## **WALMART #991 SUBDIVISION**

APPLICATION NUMBER 6 DATE March 2, 2023

REQUEST Subdivision

# DETAIL SITE PLAN

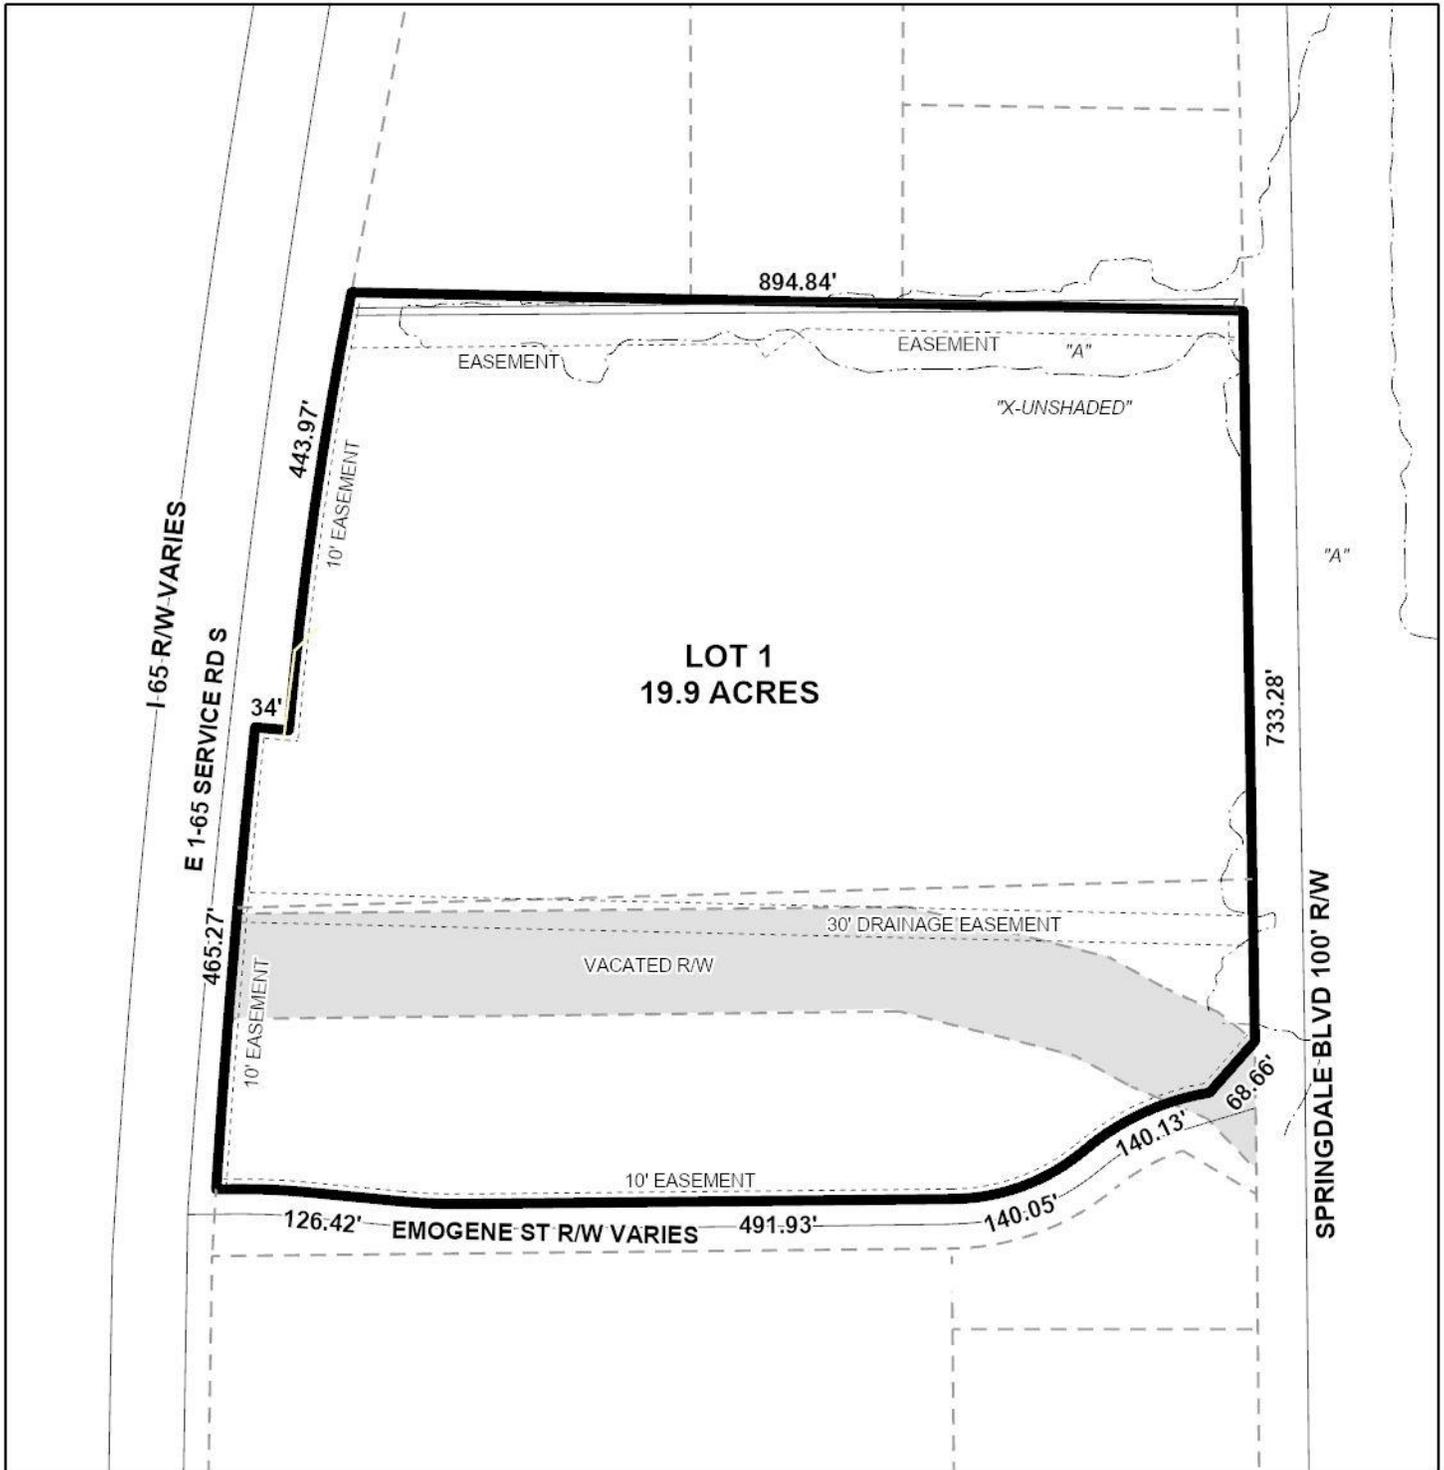
- B. Add a Curve Data Table for the eight (8) curves listed (C1-C8).
- C. Add a graphic scale.
- D. Include the recording information for the vacated ROW on the FINAL PLAT.

- E. Show and label the MFFE (Minimum Finished Floor Elevation) on each lot that contains an A, AE, or X (shaded) flood zone designation. Coordinate with the City Engineering Department to obtain the BFE for LOT 1.

The preliminary plat submitted does not illustrate the 25-foot minimum building setback lines along all street frontages. If approved, the 25-foot minimum building setback should be illustrated along all street frontages on the Final Plat.

The preliminary plat depicts multiple easements at the site. If approved, a note should be placed on the Final Plat stating that no structure is allowed in any easement, without the approval of the easement holder.

The preliminary plat depicts a vacated right-of-way. The vacation of that right-of-way was approved on July 24, 2000 per City Council Resolution Number 47-481. If approved, the vacated right-of-way should not be illustrated on the Final Plat.

- 1) retention of the right-of-way widths along all street frontages on the Final Plat;
- 2) illustration of the 25-foot minimum building setback lines along all street frontages on the Final Plat;

- 3) placement of a note should be placed on the Final Plat stating that no structure is allowed in any easement, without the approval of the easement holder;

- 4) removal of the vacated right-of-way on the Final Plat;
- 5) compliance with the Engineering comments: (*FINAL PLAT COMMENTS (should be addressed prior to submitting the FINAL PLAT for review and/or signature by the City Engineer): A. Provide all of the required information on the SUBDIVISION PLAT (i.e. signature blocks, signatures, certification statements, written legal description, required notes, legend, scale, bearings and distances) that is required by the current Alabama State Board of Licensure for Professional Engineers and Land Surveyors. B. Add a Curve Data Table for the eight (8) curves listed (C1-C8). C. Add a graphic scale. D. Include the recording information for the vacated ROW on the FINAL PLAT. E. Show and label the MFFE (Minimum Finished Floor Elevation) on each lot that contains an A, AE, or X (shaded) flood zone designation. Coordinate with the City Engineering Department to obtain the BFE for LOT 1. F. Add a note to the SUBDIVISION PLAT stating that as shown on the 1984 aerial photo (FLIGHT 24 - #76) LOT 1 will receive the historical credit of existing (1984) impervious area towards stormwater detention requirement per Mobile City Code, Chapter 17, Storm Water Management and Flood Control) as follows: LOT 1 – NONE. G. Add a note that a Land Disturbance permit will be required for any land disturbing activity in accordance with Mobile City Code, Chapter 17, Storm Water Management and Flood Control); the City of Mobile, Alabama Flood Plain Management Plan (1984); and, the Rules For Erosion and Sedimentation Control and Storm Water Runoff Control. H. Add a note that the approval of all applicable federal, state, and local agencies (including all storm water runoff, wetland and floodplain requirements) will be required prior to the issuance of a Land Disturbance permit. I. Add a note that sidewalk is required to be constructed, and/or repaired, along the frontage of each lot, or parcel, at time of new development or construction, unless a sidewalk waiver is approved. J. Add a note that all existing and proposed detention facilities, common areas, and wetlands shall be the responsibility of the Property Owner(s), and not the responsibility of the City of Mobile. K. Add a note that all easements shall remain in effect until vacated through the proper Vacation process. L. Email a pdf copy of the FINAL SUBDIVISION PLAT and LETTER OF DECISION to the Permitting Engineering Dept. for review at land.disturbance@cityofmobile.org prior to obtaining any signatures. No signatures are required on the drawing.*)
